Final Product/Process Change Notification

Document #:FPCN24698X

Title of Change:	Lead Frame Vendor and Design change for QFN15 Products Assembled in UTAC (UTL) , Bangkok, Thailand.	
Proposed First Ship date:	08 Nov 2022 or earlier if approved by customer	
Contact Information:	Contact your local onsemi Sales Office or Marty.Paul@onsemi.com	
PCN Samples Contact:	Contact your local onsemi Sales Office. Sample requests are to be submitted no later than 30 days from the date of first notification, Initial PCN or Final PCN, for this change. Samples delivery timing will be subject to request date, sample quantity and special customer packing/label requirements.	
Additional Reliability Data:	Contact your local onsemi Sales Office or Shiela.Crosby@onsemi.com	
Type of Notification:	This is a Final Product/Process Change Notification (FPCN) sent to customers. FPCNs are issued 90 days prior to implementation of the change. onsemi will consider this change accepted, unless an inquiry is made in writing within 30 days of delivery of this notice. To do so, contact PCN.Support@onsemi.com

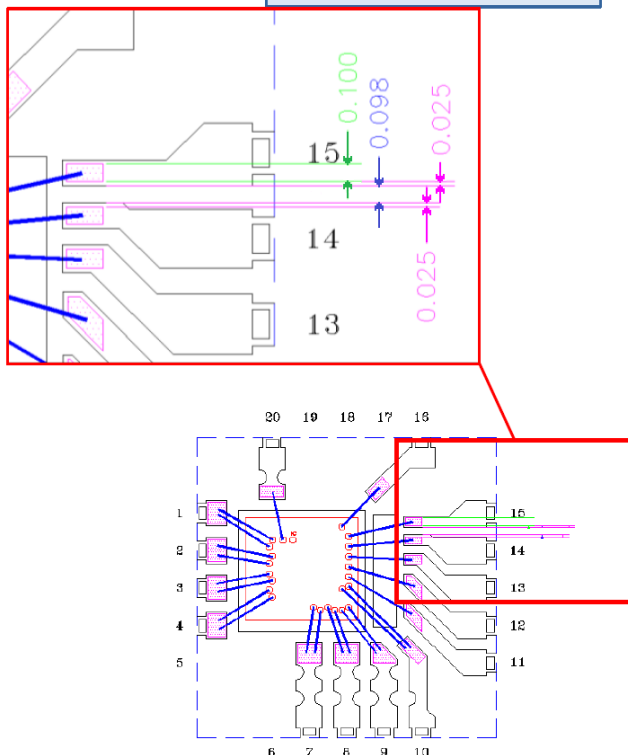
Marking of Parts/ Traceability of Change:	Affected products will be identified with date code. Products may contain either leadframe vendor after the 90day expiration of this FPCN. Contact onsemi for the exact date code.	
Change Category:	Assembly Change	
Change Sub-Category(s):	Material Change	
Sites Affected:		
onsemi Sites	External Foundry/Subcon Sites	
None	UTAC, Thailand	
Description and Purpose:		
This is an FPCN to notify customers that onsemi has completed qualification of a new vendor for the leadframe in the QFN-15 package assembled at the UTAC, Bangkok Thailand location for the products listed in this announcement. The previous vendor has discontinued their leadframe product. As a result, the following changes will occur:		
	Before Change Description	After Change Description
LeadFrame	Lead frame vendor CWTC with 0.30-1.2 microinch bottom plating	Lead frame vendor Rokko with 1.38 microinch bottom plating and below dimension changes.

Current design CWTC supplier

Rokko supplier
